DRESDEN RADIATION PROCEDURE
DRP 37-1-B-1, CONTROL OF PERSONNEL
EXTERNAL EXPOSURES TO RADIATION

CECO. RESPONSE TO NRC ROUND 1, QUESTION 1

VOLUME DISPLACEMENT OF RACK

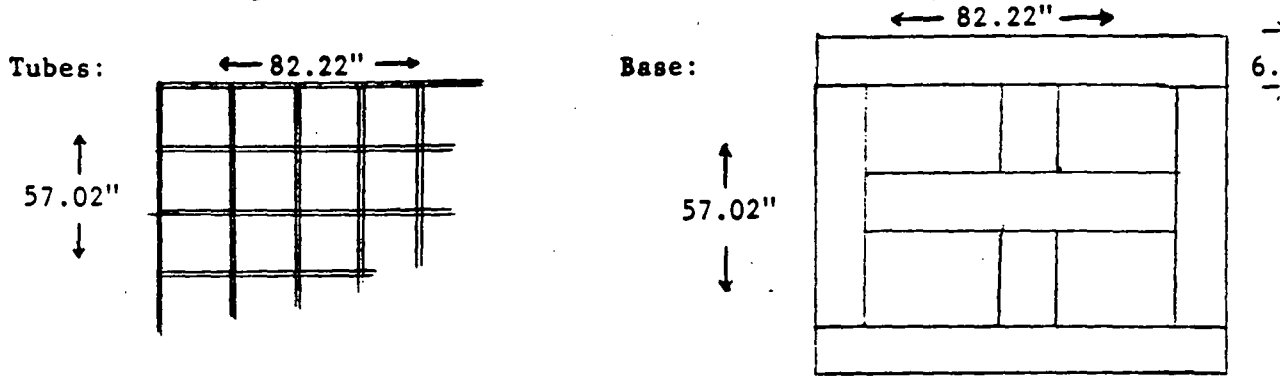
Use the largest type 9 x 13 rack (vs. 9 x 11).

Assumption 1: Volume of the six legs is negligible.

Assumption 2: Wall thickness is a constant .217 inches from top to bottom of tube (actually it tapers at top and bottom where there is no Boral)

$$V_t = \frac{10 \times (.217 \times 82.22 \times 168)}{12^3} + \frac{14 \times (.217 \times 57.02 \times 168)}{12^3}$$

$$- \frac{10 \times 14 \times (.217^2 \times 168)}{12^3} = 31.1 \text{ ft}^3$$

$$V_b = 3 \times 82.22 \times 6.62 \times .75 + 3 (57.02 - 3 \times 6.62 \times 6.62 \times .75) = 1.02 \text{ ft}^3$$

Total Volume = 31.1 + 1.0 = 32.1 ft³ = 240 gal.

$$\text{Water Level from Rack} = \frac{32.1 \text{ ft}^3}{1353 \text{ ft}^2} = .0237 \text{ ft.} = .28"$$
